Dam Safety Assessment of CCW Impoundments

Joppa Plant

May 27, 2010

Prepared for:
US Environmental Protection Agency
Washington, DC

PHOTO LOCATIONS
AND SITE FEATURES

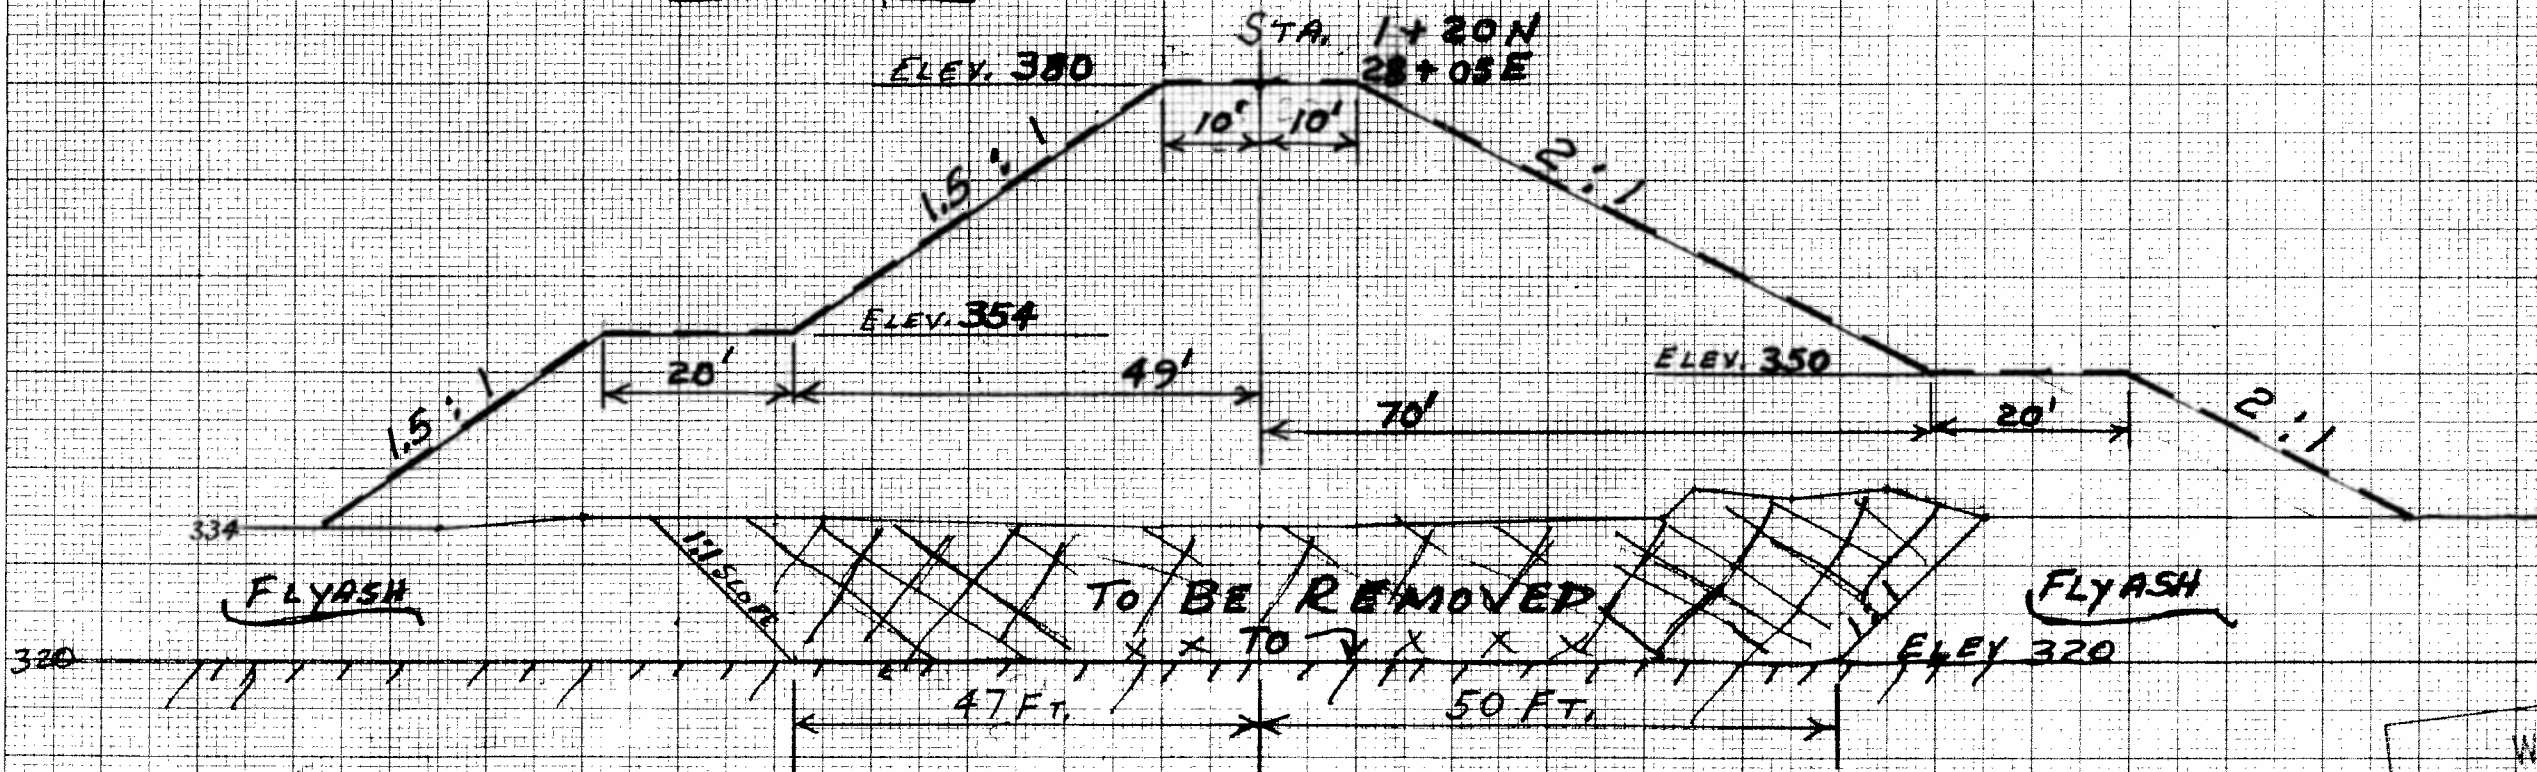
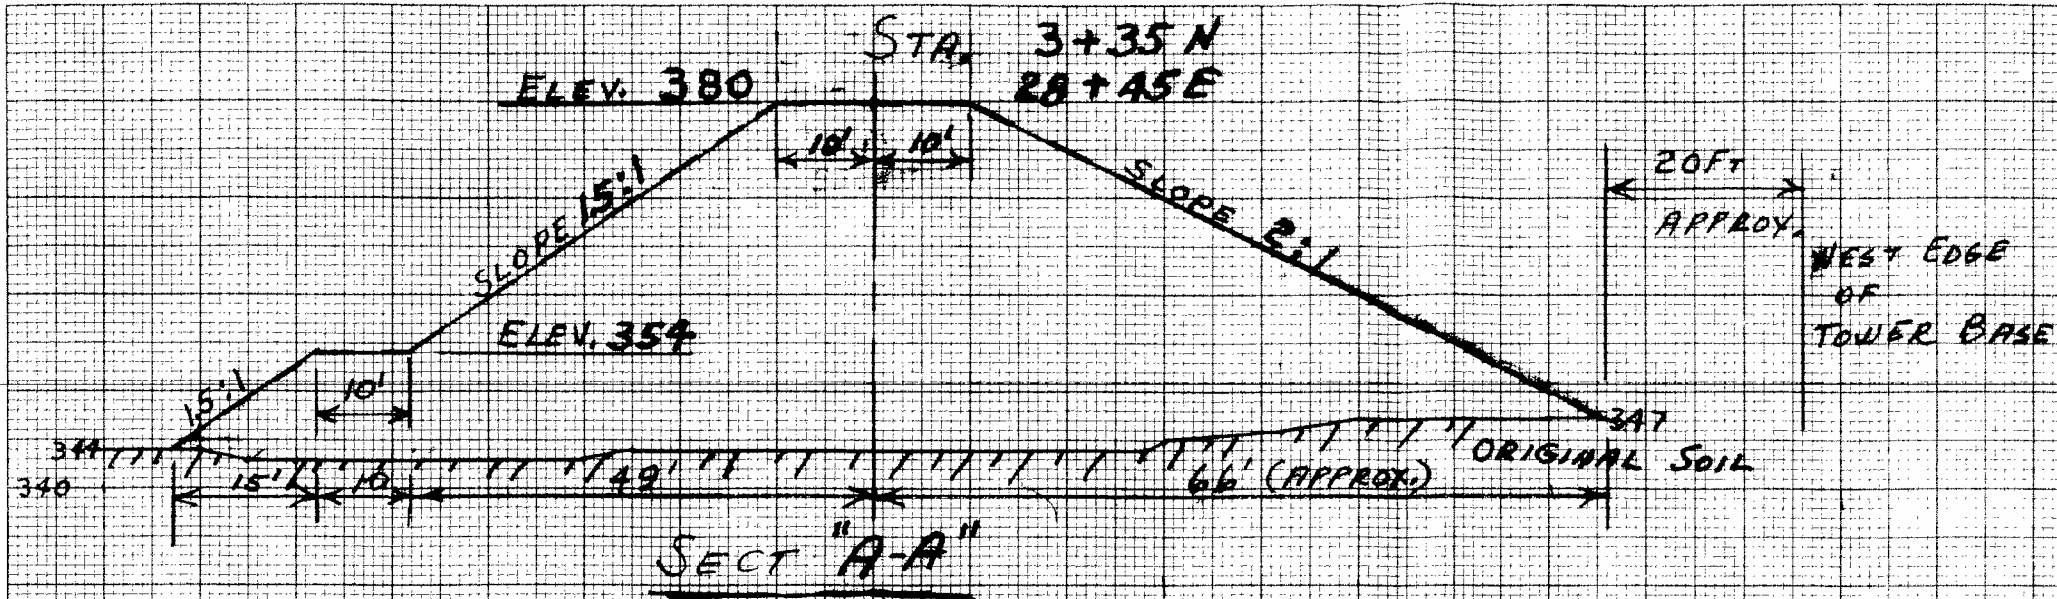
- CCW has accumulated above the normal pool level over an estimated 90 percent of the pond area. Water in the pond is isolated to primarily the northeastern corner (Figures 2 & 3, Photos 4 & 5).

- CCW has accumulated above the normal pool level over an estimated 50 percent of the pond area. Water in the pond is isolated to primarily the eastern half of the pond (Figures 2 & 3, Photo 17).

- Seepage was observed in multiple locations along the outboard toe of the embankment. The most significant area of seepage is located approximately 500 feet north of the power lines (Photos 23 & 24). Other areas where seepage was observed include an area approximately 200 feet south of the power lines and along the southern embankment of the Southern Pond. The approximate locations of seepage are identified on Figure 3.

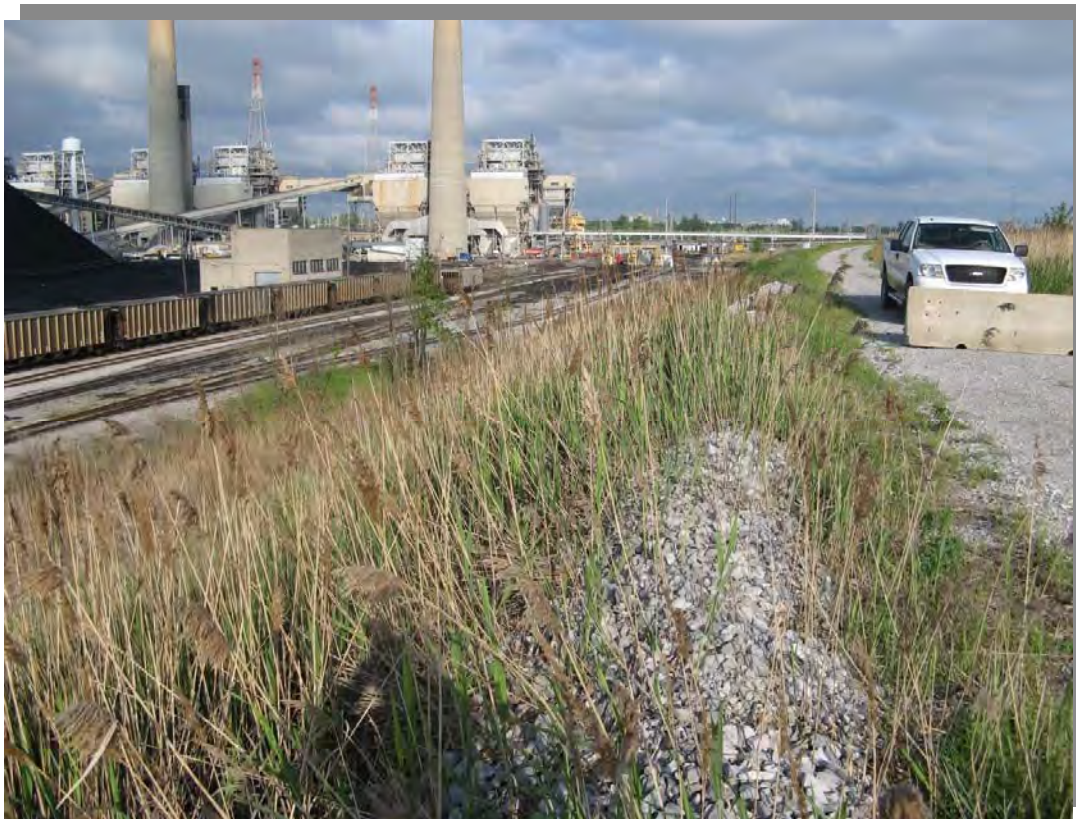
- Sluiced CCW by-product discharge enters the pond in the southwestern corner (Photo 13) and flows along the southern embankment in a channel dredged into dried CCW (Photo 14). Sluice water exits the pond through a 24-inch steel "T" structure located near the northeast corner of the impoundment (Photos 15 & 16).
